S8JX-P Series Replacement Brackets

Original model mounting method	Replacement model: S8JX-P	Replacement model: S8FS-G	Replacement bracket	
	Models no longer available to order (except for the S8JX-P300/600)	Recommended replacement model	Model	Page
Bottom mounting	S8JX-P050□□	S8FS-G050□□	S82Y-FSG-B02	page 2
	S8JX-P100□□	S8FS-G100□□	S82Y-FSG-B03	page 3
	S8JX-P150□□	S8FS-G150□□	S82Y-FSG-B04	page 4
	S8JX-P300□□	S8FS-G300□□	S82Y-FSG-B05	page 5
	S8JX-P600□□	S8FS-G600□□	S82Y-FSG-B07	page 6
Front mounting	S8JX-P050□□	S8FS-G050□□	S82Y-FSG-F31	page 7
	S8JX-P100□□	S8FS-G100□□	S82Y-FSG-F32	page 8
	S8JX-P150□□	S8FS-G150□□		
	S8JX-P300□□	S8FS-G300□□	S82Y-FSG-F36	page 9
	S8JX-P600□□	S8FS-G600□□	S82Y-FSG-F38	page 10
Side mounting	S8JX-P050□□	S8FS-G050□□	S82Y-FSG-S22	page 11
	S8JX-P100□□	S8FS-G100□□	S82Y-FSG-S23	page 12
	S8JX-P150□□	S8FS-G150□□	S82Y-FSG-S24	page 13
	S8JX-P300□□	S8FS-G300□□	S82Y-FSG-S25	page 14
	S8JX-P600□□	S8FS-G600□□	S82Y-FSG-S26	page 15

S8JX-P050 □ □

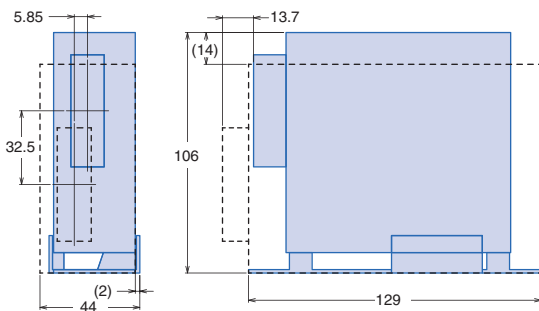
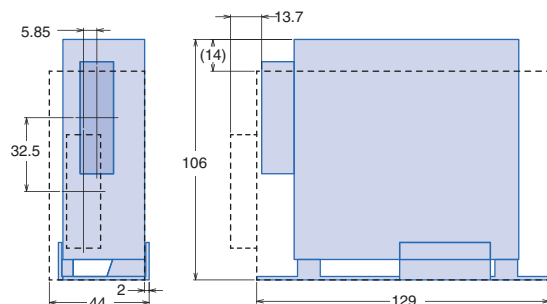
Mounting dimension differences before/after replacement

■ S8FS-G + Replacement bracket, □ S8JX-P Series

Mounting using replacement bracket mounting holes	Mounting using replacement bracket screw holes
Processing dimensions		
Mounting Method	<p>Recommended tightening torque M3 : 0.54 N·m</p> <p>Note: The figure above shows the mounting direction for S82Y-FSG-B01, a similar product. The shape of S82Y-FSG-B02 will be slightly different.</p>	<p>Recommended tightening torque M3 : 0.54 N·m</p> <p>Note: 1. The figure above shows the mounting direction for S82Y-FSG-B01, a similar product. The shape of S82Y-FSG-B02 will be slightly different. 2. Be cautious of the length of the screws being used to avoid interference with the power supply unit.</p>

S8JX-P100□□

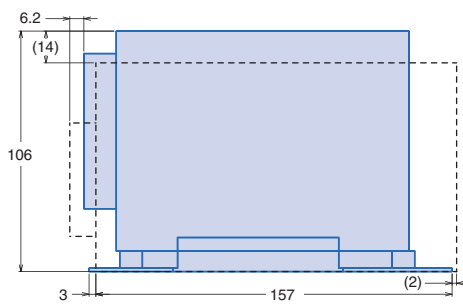
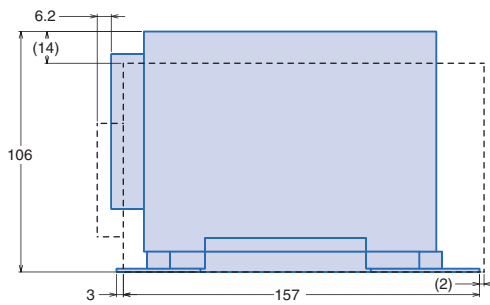
Mounting dimension differences before/after replacement

■ S8FS-G + Replacement bracket, □ S8JX-P Series

Mounting using replacement bracket mounting holes	Mounting using replacement bracket screw holes
Processing dimensions		
Mounting Method	<p>Note: The figure above shows the mounting direction for S82Y-FSG-B01, a similar product. The shape of S82Y-FSG-B03 will be slightly different.</p>	<p>Note: 1. The figure above shows the mounting direction for S82Y-FSG-B01, a similar product. The shape of S82Y-FSG-B03 will be slightly different. 2. Be cautious of the length of the screws being used to avoid interference with the power supply unit.</p>

S8JX-P150 □ □

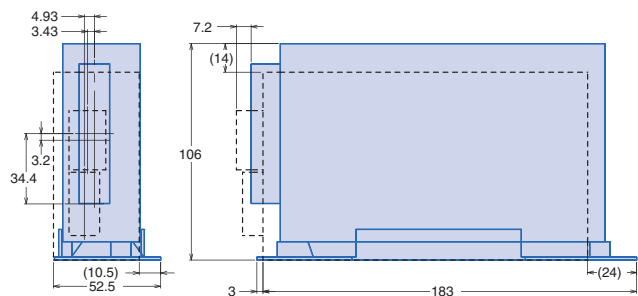
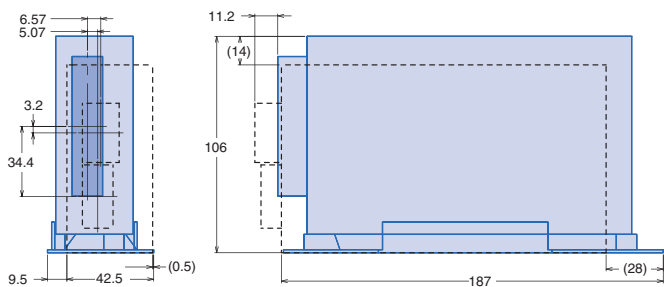
Mounting dimension differences before/after replacement

■ S8FS-G + Replacement bracket, □ S8JX-P Series

Mounting using replacement bracket mounting holes	Mounting using replacement bracket screw holes
Processing dimensions	<p>M3 150 ± 0.2</p>	<p>3.5 dia. 98 ± 0.2</p>
Mounting Method	<p>(1) (2)</p> <p>Included screws Recommended tightening torque M3 : 0.54 N·m</p> <p>Note: The figure above shows the mounting direction for S82Y-FSG-B01, a similar product. The shape of S82Y-FSG-B04 will be slightly different.</p>	<p>(1) (2)</p> <p>Included screws Recommended tightening torque M3 : 0.54 N·m</p> <p>Note: 1. The figure above shows the mounting direction for S82Y-FSG-B01, a similar product. The shape of S82Y-FSG-B04 will be slightly different. 2. Be cautious of the length of the screws being used to avoid interference with the power supply unit.</p>

S8JX-P300 □ □

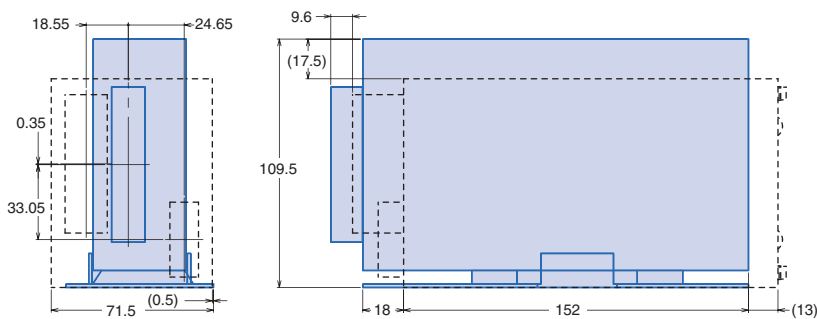
Mounting dimension differences before/after replacement

■ S8FS-G + Replacement bracket, □ S8JX-P Series

Mounting using replacement bracket screw holes	
Processing dimensions	
Mounting Method	<p>Note: 1. The figure above shows the mounting direction for S82Y-FSG-B01, a similar product. The shape of S82Y-FSG-B05 will be slightly different. 2. Be cautious of the length of the screws being used to avoid interference with the power supply unit.</p>

S8JX-P600 □ □

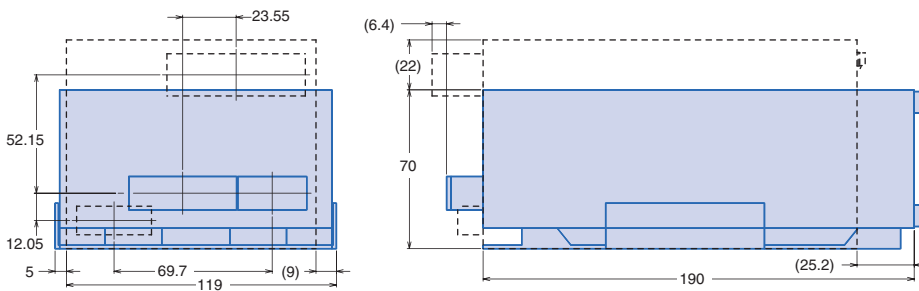
Mounting dimension differences before/after replacement

S8FS-G + Replacement bracket,
 S8JX-P Series

Mounting using replacement bracket screw holes	
Processing dimensions	
Mounting Method	<p>Recommended tightening torque M4 : 1.2 N·m</p> <p>Included screws</p> <p>Note: Be cautious of the length of the screws being used to avoid interference with the power supply unit.</p>

S8JX-P050□□

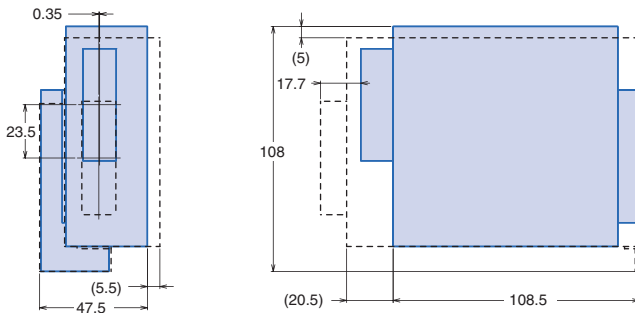
Mounting dimension differences before/after replacement

S8FS-G + Replacement bracket,
 S8JX-P Series

Mounting using replacement bracket mounting holes	
Processing dimensions	
Mounting Method	<div style="display: flex; justify-content: space-around;"> <div style="text-align: center;"> <p>(1)</p> <p>Included screws</p> </div> <div style="text-align: center;"> <p>(2)</p> <p>Recommended tightening torque M3 : 0.54 N·m</p> </div> </div> <p>Note: The figure above shows the mounting direction for S82Y-FSG-F32, a similar product. The shape of S82Y-FSG-F31 will be slightly different.</p>

S8JX-P100 □ □

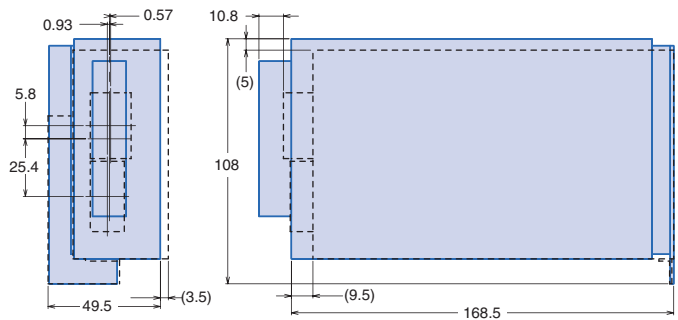
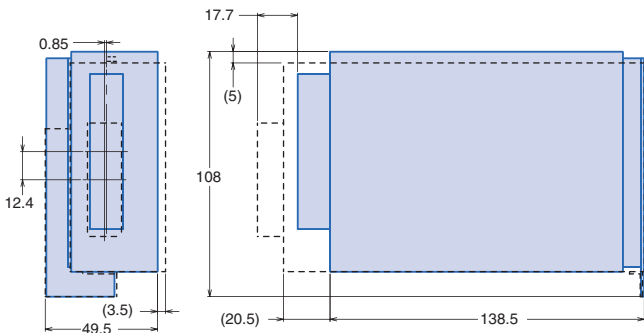
Mounting dimension differences before/after replacement

■ S8FS-G + Replacement bracket, □ S8JX-P Series

S8JX-P300 □ □

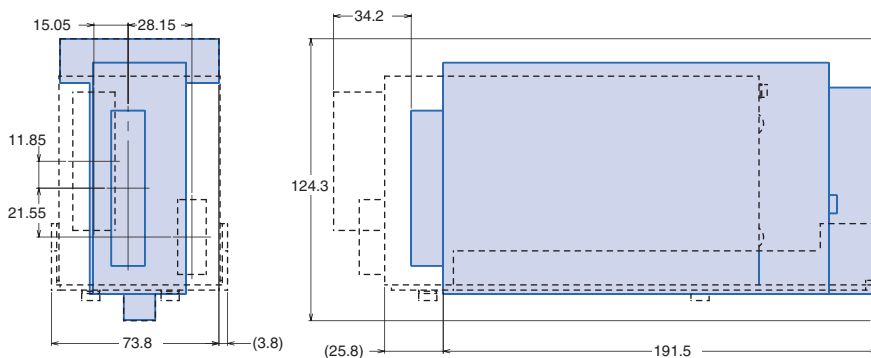
Mounting dimension differences before/after replacement

■ S8FS-G + Replacement bracket, □ S8JX-P Series

Mounting using replacement bracket mounting holes	
Processing dimensions	
Mounting Method	<p>Recommended tightening torque M4 : 1.2 N·m</p>

S8JX-P600 □ □

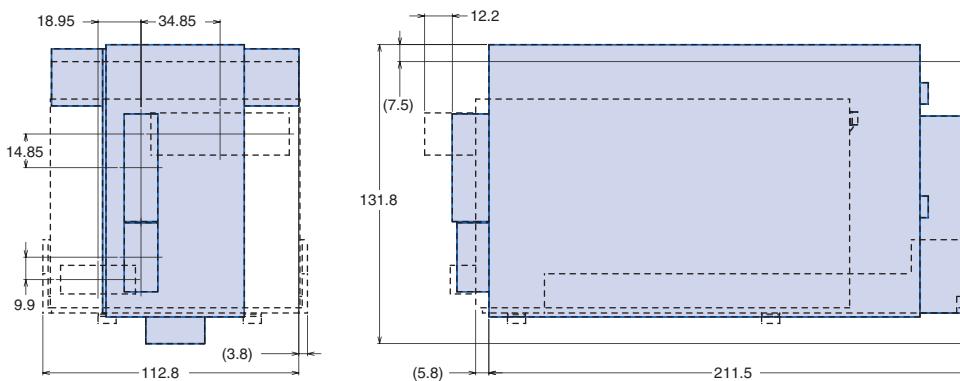
Mounting dimension differences before/after replacement

■ S8FS-G + Replacement bracket, □ S8JX-P Series

Note: The figure above shows the mounting direction for S82Y-FSG-F37, a similar product. The shape of S82Y-FSG-F38 will be slightly different.

S8JX-P050 □ □

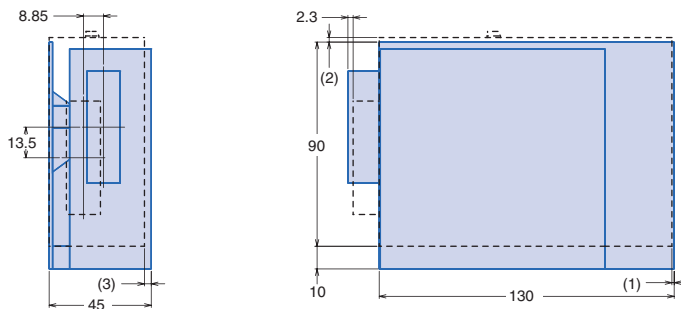
Mounting dimension differences before/after replacement

■ S8FS-G + Replacement bracket, [] S8JX-P Series

S8JX-P100 □ □

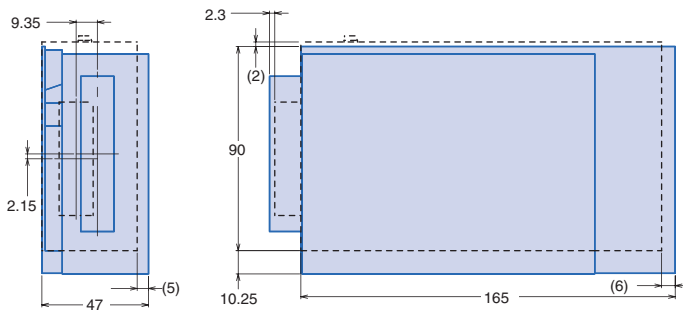
Mounting dimension differences before/after replacement

■ S8FS-G + Replacement bracket, □ S8JX-P Series

Mounting using replacement bracket mounting holes	
Processing dimensions	
Mounting Method	<p>Note: The figure above shows the mounting direction for S82Y-FSG-S22, a similar product. The shape of S82Y-FSG-S23 will be slightly different.</p>

S8JX-P150 □ □

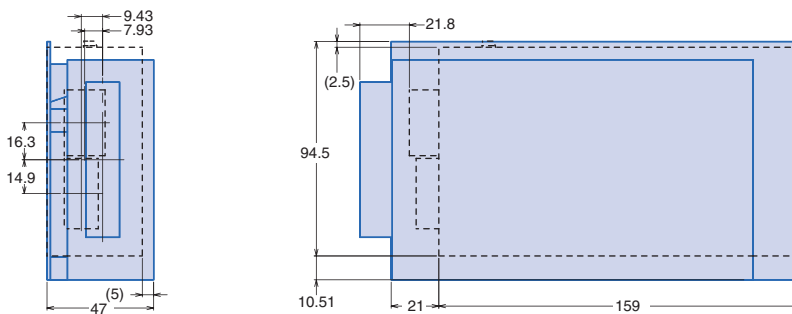
Mounting dimension differences before/after replacement

■ S8FS-G + Replacement bracket, □ S8JX-P Series

Mounting using replacement bracket mounting holes	
Processing dimensions	
Mounting Method	<p>Note: The figure above shows the mounting direction for S82Y-FSG-S22, a similar product. The shape of S82Y-FSG-S24 will be slightly different.</p>

S8JX-P300 □ □

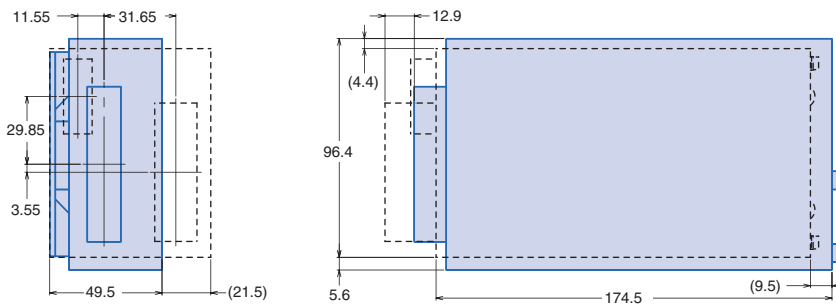
Mounting dimension differences before/after replacement

■ S8FS-G + Replacement bracket, □ S8JX-P Series

Mounting using replacement bracket screw holes	
Processing dimensions	
Mounting Method	<div style="display: flex; justify-content: space-around;"> <div style="text-align: center;"> <p>(1)</p> </div> <div style="text-align: center;"> <p>(2)</p> </div> </div> <p style="text-align: right;">Recommended tightening torque M4 : 1.2 N·m</p> <p>Note: 1. The figure above shows the mounting direction for S82Y-FSG-S22, a similar product. The shape of S82Y-FSG-S25 will be slightly different. 2. Be cautious of the length of the screws being used to avoid interference with the power supply unit.</p>

S8JX-P600 □ □

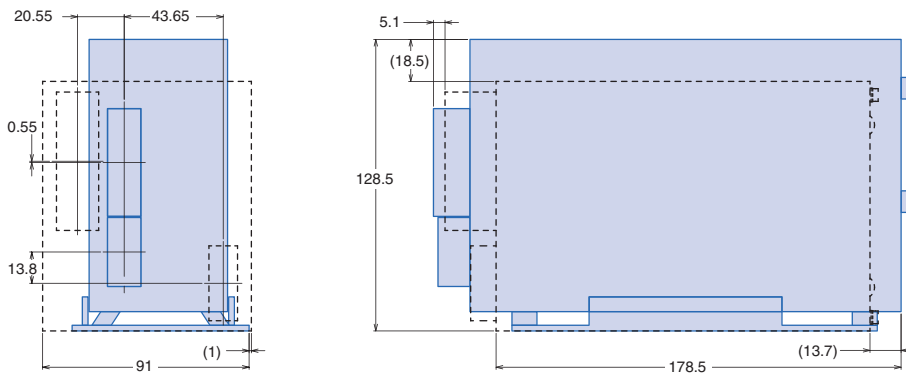
Mounting dimension differences before/after replacement

■ S8FS-G + Replacement bracket, □ S8JX-P Series

Mounting using replacement bracket screw holes	
Processing dimensions	<p>Diagram showing the processing dimensions for the replacement bracket screw holes. The dimensions are 125 ± 0.2 mm in width and 50 ± 0.2 mm in height. The holes are 4.5 mm in diameter.</p>
Mounting Method	<p>Diagram illustrating the mounting method in two steps: (1) The replacement bracket is positioned below the device. (2) The bracket is attached to the device using screws. The included screws are shown being inserted into the bracket's holes. Recommended tightening torque for M4 screws is 1.2 N·m.</p> <p>Note: Be cautious of the length of the screws being used to avoid interference with the power supply unit.</p>
